Product Change Notification / JAON-23VTYQ024

CCB 4611 Final Notice: Qualification of MMT as an additional assembly site for selected Microsemi PD69101ILQ-TR and PD69101ILQ-13155TR catalog part numbers (CPN) available in 24L VQFN (4x5x1.0mm) package.

NSEB LF

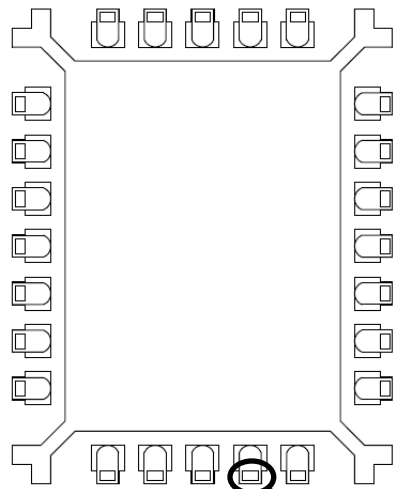
Lead frame material	EFTEC-64T
Lead frame Paddle size	114x154 mils
Lead-lock (Locking Hole)	Yes

UNIC LF

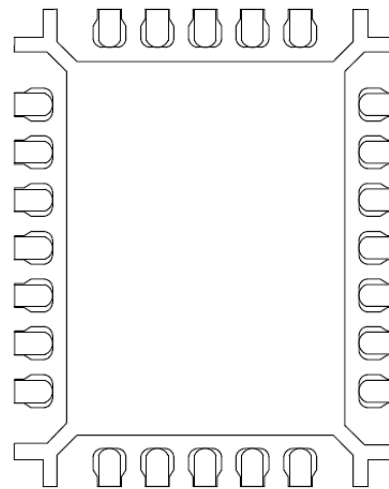
Lead frame material	A194
Lead frame Paddle size	114x154 mils
Lead-lock (Locking Hole)	No

MMT LF

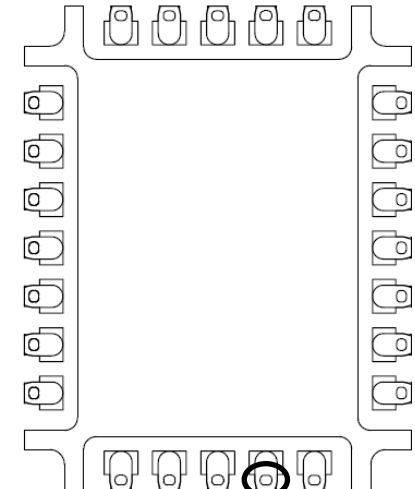
Lead frame material	A194
Lead frame Paddle size	114x154 mils
Lead-lock (Locking Hole)	Yes

Note: Mold compound material fills the leadlock hole, which provides improved protection against moisture penetration along the edge of the leads (pins) of the package.
